**APPROVAL** of a request to rezone subject property from “R1-60” One-Family Low-Density Residential District to Limited “C-1” Neighborhood Retail Commercial District to allow for development of the property for a drive-through restaurant, subject to the property owner agreeing to the following conditions: (ZON2008-00002)

Imperial Properties Inc. (Wendy's Restaurant)- 605 E 15th Street

Project:  
 IMPERIAL PROPERTIES  
 WENDYS RESTAURANT  
 1500-1512 DES MOINES STREET  
 DES MOINES, IOWA

CONCEPT SITE PLAN 4 lots 1500, 1504, 1508, & 1512  
 A 1/16" = 1'-0"

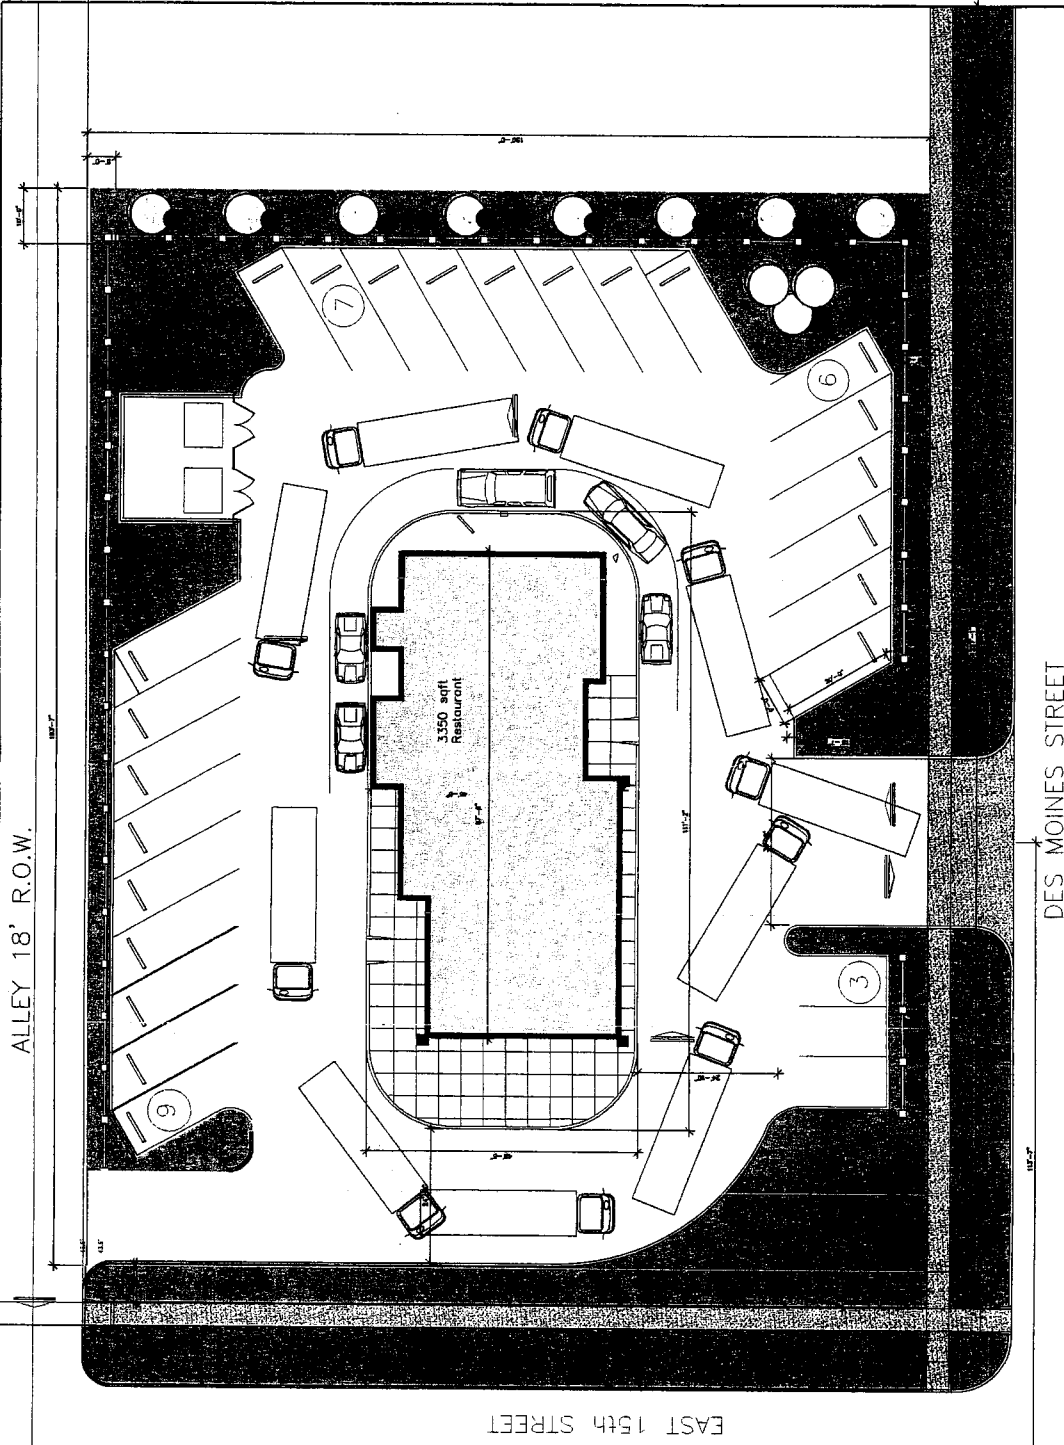
Tim Urban: Asked if the applicant had worked with staff on the concept plan for the area. Expressed concern for the access point mid-block and suggested an alternative would be to access through the easterly portion of their parking lot with a vertical access drive.

Mike Ludwig: Noted staff did not review the concept plan for the remainder of the block for code compliance. A problem with asking for the proposed drive to be shifted east would be putting the entrance right next to the existing residence.

Bruce Heilman: Asked if there would be a better place for the dumpster further to the west.

Erik Lundy: Noted putting the dumpster too far away from where the refuse comes out of the building could create a problem. Noted currently it is approximately 20-35 feet from the east property line. Noted the Commission has the ability to add the condition.

Tim Urban: Noted much of the angled parking has bumper curbs on them. Asked that they create a straight curb, as the bumper curbs tend to trap trash.

Tim Urban: Asked if the fence was proposed to continue west of the main entry drive and asked why it was necessary.

Bruce Heilman: Asked if the 6' opaque fence would be extended down the north side.

Erik Lundy: Noted the site wall to the south would be required unless a 3' fence or berm was installed because the zoning to the south is R1-60. Also, a six foot wood fence would be required along the north property line. The applicant could go to the Board of Adjustment to request a waiver of those requirements.

- All non-building mounted signs be monument type only;
- Site plan return to the Commission for review and approval if the submitted site plan is not in substantial compliance with the concept plan presented at the rezoning hearing;
- Applicant work with staff on the elimination of the fence on Des Moines Street west of the entry drive and along the north property line, west of the dumpsters.

(A) CONCEPT HIGH SCREENING WALL

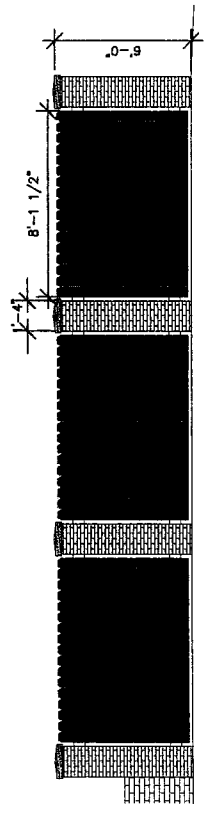
The applicant has submitted a schematic that provided for a six-foot high solid wood fence with stone capped brick masonry pillars between fencing panels. The schematic also provides detail for a three-foot high brick masonry site wall with stone capped brick masonry pillars between wall sections, to be placed along the Des Moines Street landscaped perimeter. The fence is shown abutting the parking lot with landscaping planted toward the adjoining residence. Staff would evaluate this with any submitted Site Plan to determine if the fence is better placed at the property line for reasons of maintenance of the landscaped area and to accommodate snow removal.

The minimum required buffer yard to protect residential property to the east would require three overstory and nine evergreen plantings along with a six foot solid screen fence. This would be required within a minimum 10 foot setback from any off-street parking. The submitted schematic shows eight overstory trees and 10 evergreen trees in the buffer yard which would exceed this requirement. Any Site Plan developed for the proposed restaurant site would also require overstory and tree plantings along the Des Moines Street and 15<sup>th</sup> Street sides at a rate of one tree and three shrubs per 50 lineal feet. The submitted schematic only shows the shrubs along the Des Moines Street side at this time.

4. A six-foot high solid wood fence with masonry pillars shall be used to meet required bufferyard screening from residential property to the east in general compliance with the submitted design schematic.

6. A three-foot high masonry site wall shall be used to meet the parking requirement from Des Moines Street in general compliance with the submitted design schematic.
